Federal Motor Vehicle Safety Standards; Head Restraints

ACTION: Final rule; technical amendments; response to petitions for reconsideration and petitions for rulemaking.

SUMMARY: This document responds to petitions for reconsideration of the agency's May 2007 final rule amending our head restraint standard, and to related petitions for rulemaking. This document also makes technical corrections. The May 2007 final rule was issued in response to petitions for reconsideration of our December 2004 final rule upgrading our head restraint standard. We are partially granting and partially denying the petitions for reconsideration.

Figure 1

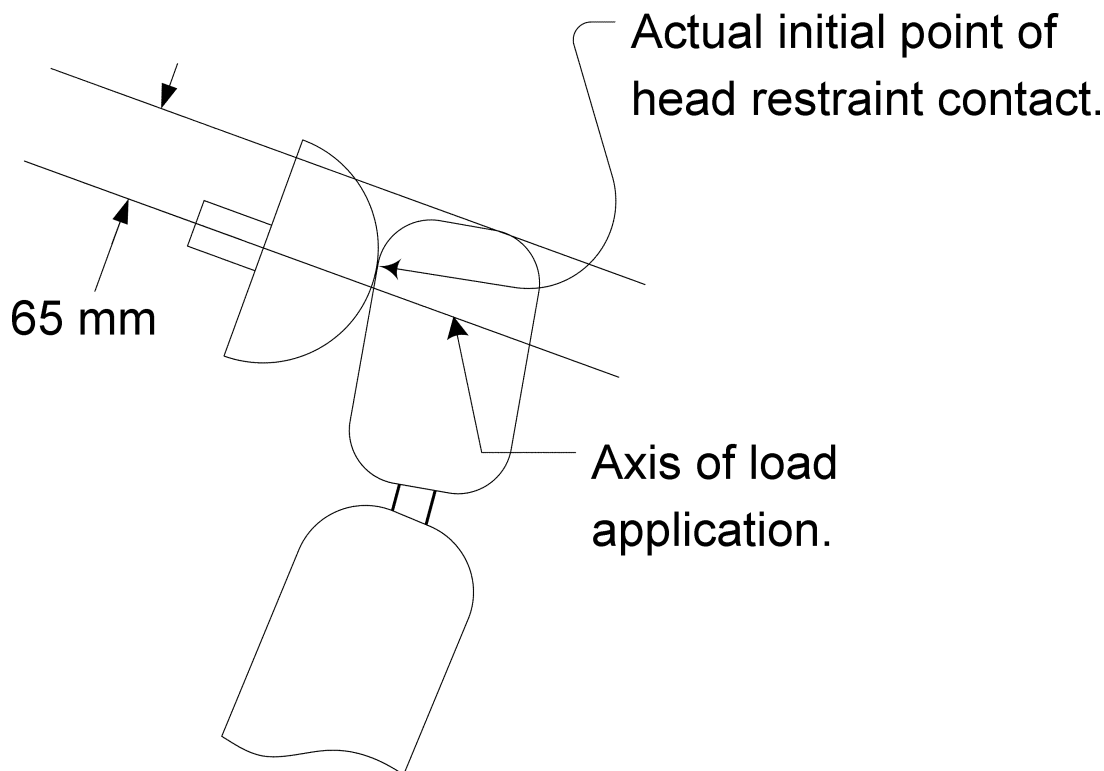
Kongsberg requested that the agency clarify the test procedure in such a way that specifies that the load vector is applied through the centerline of the head form at a height 65 mm +/- 3 mm below the top of the head restraint.

NHTSA believes that the Kongsberg interpretation of the test procedure specified in S5.2.7 of FMVSS No. 202a is correct. In fact, this test is derived from paragraph S5.2 of the version of FMVSS No. 202 now in force, which allows for the use of a cylinder to apply the required force. When a cylinder is used to apply the force, because of the shape or angle of the head restraint, it may not make it possible to assure the point of contact is 65 mm below the top of the head restraint or to do so may result in a position of the axis of load application far from the 65 mm position. However, the axis of load application

can be controlled. Although paragraph S5.2.7 of FMVSS No. 202 specifies a spherical head form loading device, the concept of aligning the axis of load application, represented by the centerline of the head form, remains the same (see Figure 1). Thus, we believe any clarification is simply a technical correction of the existing regulatory text. We are therefore revising S5.2.7(a)(5) to provide this clarification.

We note that the configuration in the illustration is for explanatory purposes only. Other configurations are acceptable if they conform to the text of the standard.
